Project 89414.00
25 May 2018
R.001.docx
GRW

Plan Review
Proposed Residential Subdivision
Picton East Development, Picton

As requested, Douglas Partners Pty Ltd (DP) has reviewed existing information and the plans titled Picton East Development Zoning Plan – Sheets 1 – 4 (Ref 12122B-E2) and Picton East Development Overall Plan – Sheets 1 – 3 (Ref 12122B-E3) by John M Daly & Associates Pty Ltd (JMD). The review was undertaken to provide geotechnical comment relevant to the road and lot layout for a proposed residential subdivision at the Picton East Development, and to assess potential impacts on the surrounding landscape.

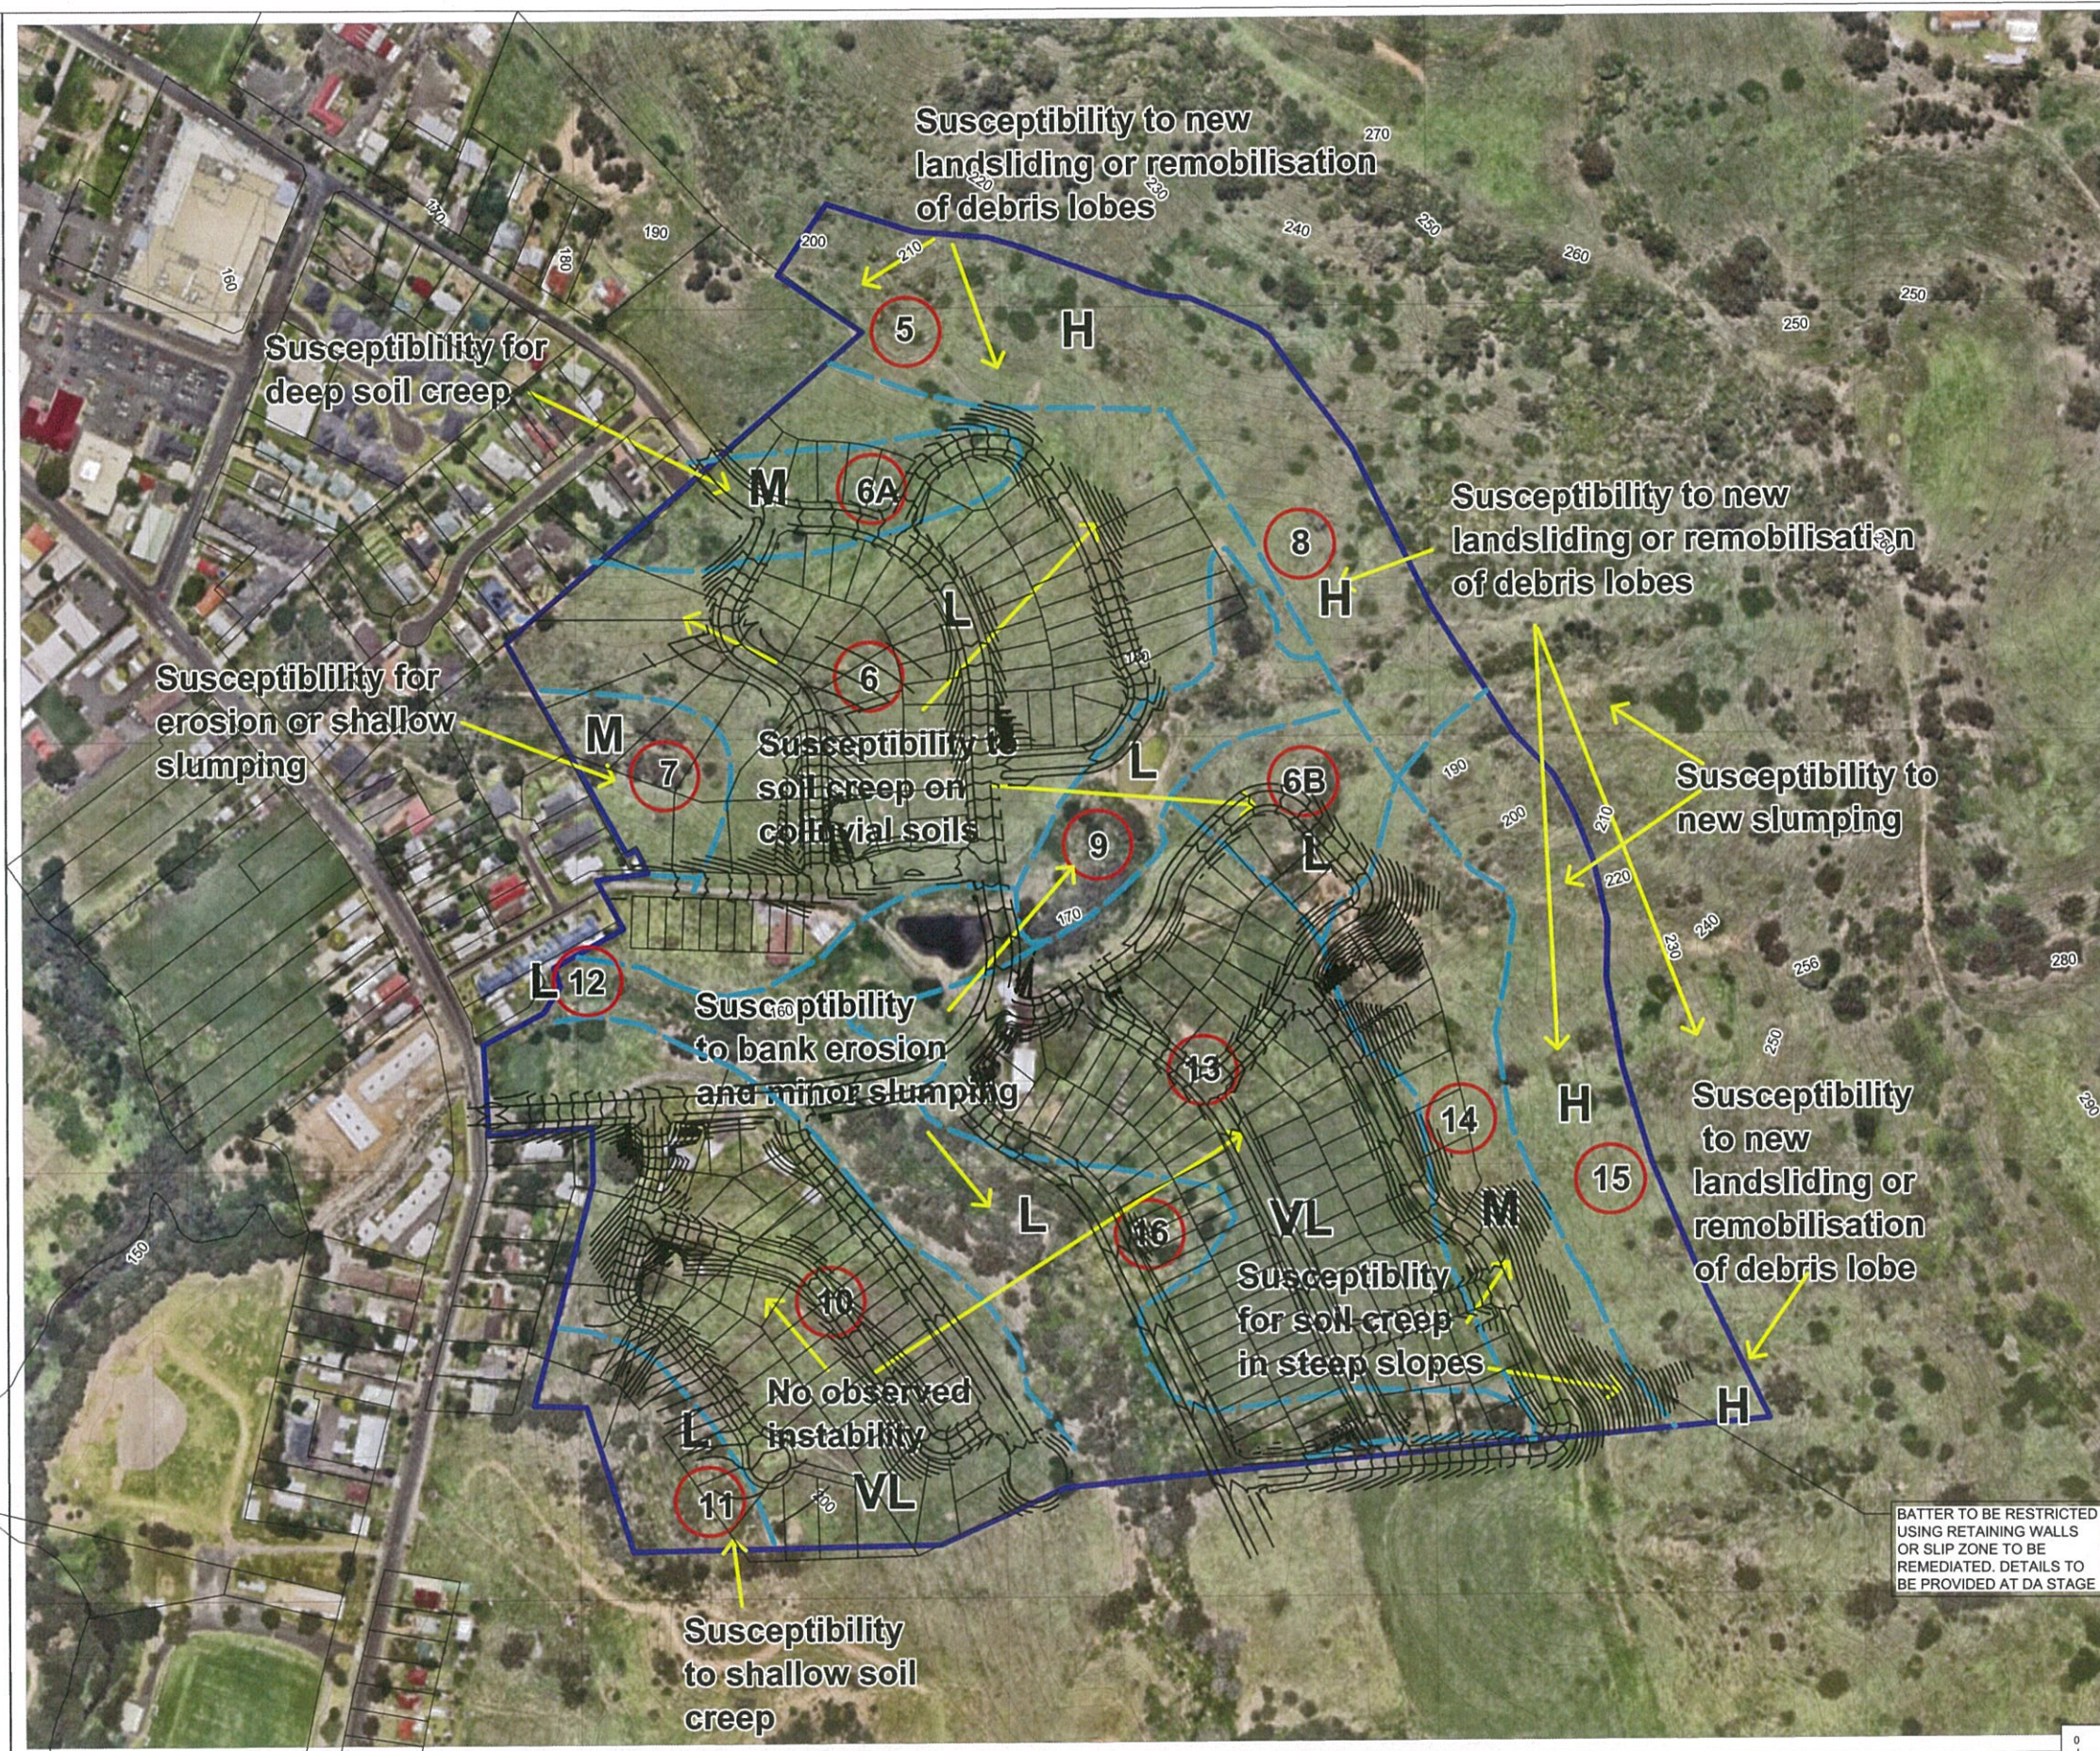
These sheets include extracts of Drawings 4 and 5 of DP Project 76579.05 that detail landslide susceptibility zones (Zones 5, 6, 6A, 6B, 7 – 16) and the distribution of constraint area. The extracts are overlain with the layout of the proposed residential lots, the alignments of new roads and proposed contour lines, representing the areas of proposed cut and fill associated with lot and road construction.

The following are comments on the distribution of development outlines shown on Sheets 1 - 3:
